BORE HOLE LOCATIONS & SOIL STRATA

LYNDE CREEK BRIDGE IN BROOKLIN

PRELIMINARY PLAN

FOUNDATION INVESTIGATION REPORT
For
New Bridge at the Crossing of Lynde
Creek & Hwy's #7 & #12 in Brooklin,
Lot 23, Con. 6, Twp. of Whitby, Co.
of Ontario, District #6 (Toronto).
W.J. 65-F-117 -- W.P. 23-65

APPROVED:	SITE No. 22-113	W.P. No. 23-65
DESIGN	BRIDGE ENGINEER	CONTRACT
DRAWING	NO.	NO.
DATE	APRIL 66	DRAWING No. D-5886-P1

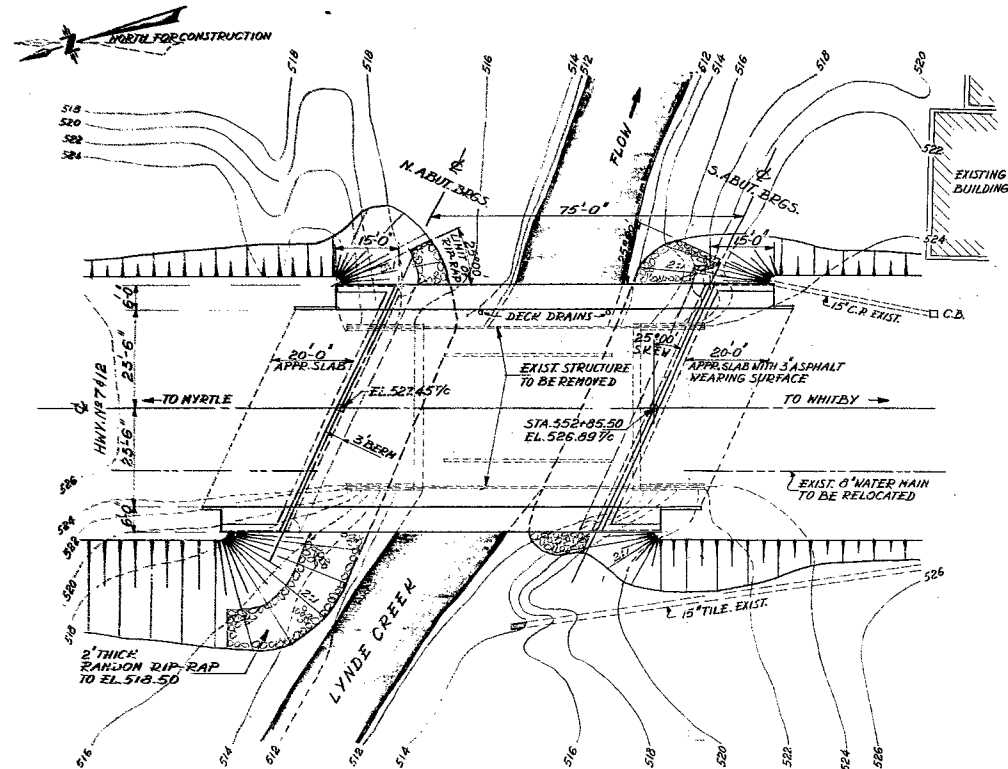
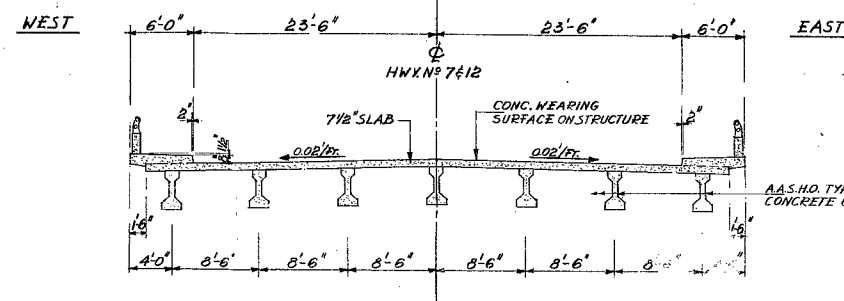
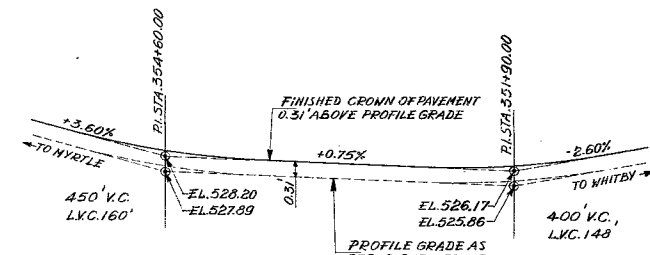
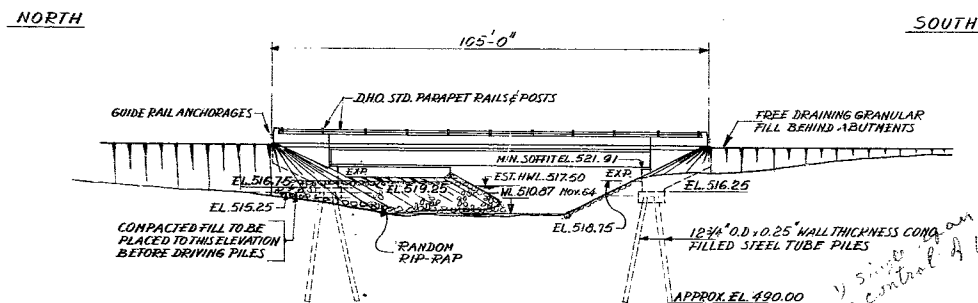
We have reviewed the preliminary drawing
D-5886-P1 for the above structure, and it appears that
the designer has complied with the recommendations
contained in the foundation report.

We have reviewed the preliminary drawing
D-5886-P1 for the above structure, and it appears that
the designer has complied with the recommendations
contained in the foundation report.

Herewith one print of the preliminary drawing
D-5886-P1 for the above structure. The recommenda-
tions of the foundation report have been followed.

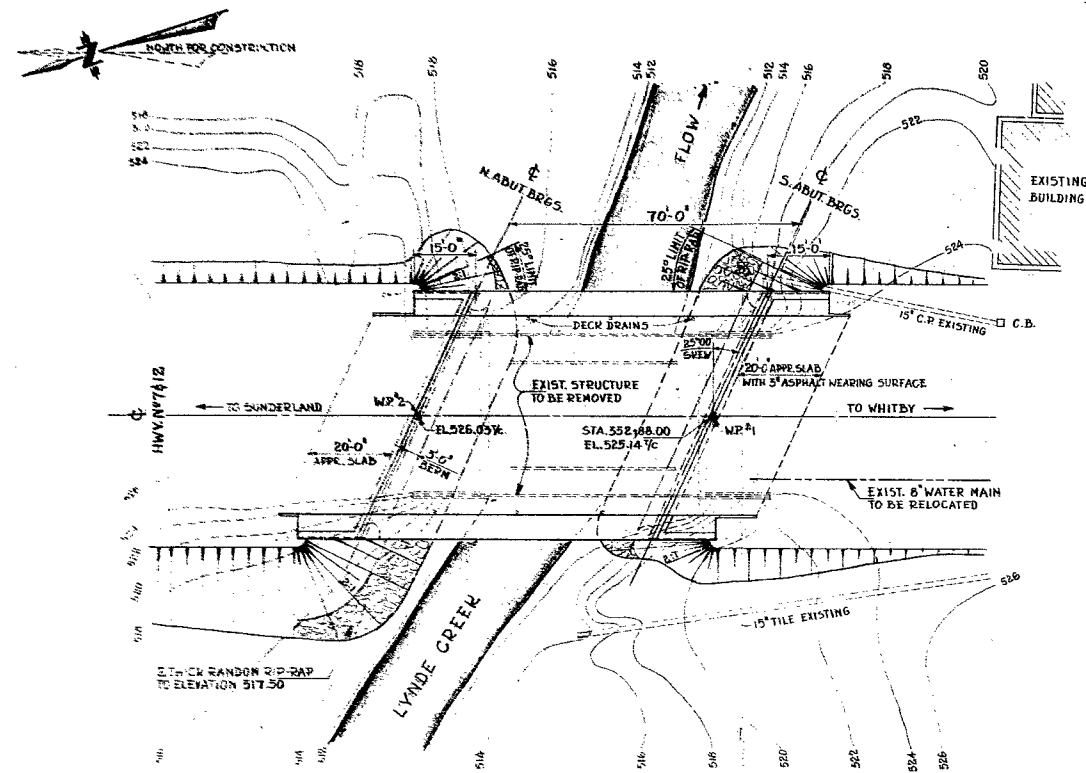
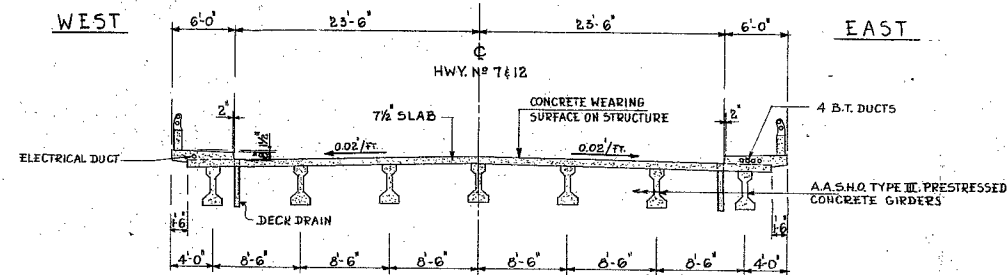
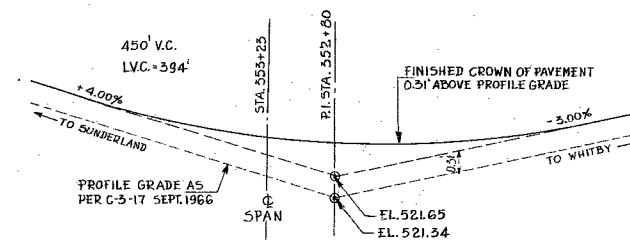
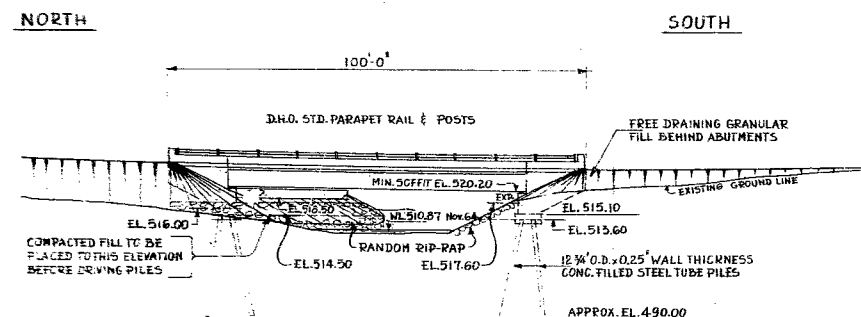
We have reviewed the preliminary drawing D-6098 P1 for the above structure, and it appears that the designer has complied with the recommendations contained in the foundation report.

No comments!
Dec 29/66 ags

REVISIONS	DATE	BY	DESCRIPTION
DEC/66	J.52		THIS DRAWG. SUPERSEDES PREVIOUS DESIGN DRAWINGS D-5886. DESIGN REVISED TO SUIT GRADE LOWERING SEPT./66

Attached for your approval is one print of Preliminary Plan D-6098 F1 for the above structure. This is basically the same design as previously issued but at a lower grade, which was issued on 26th September, 1966.
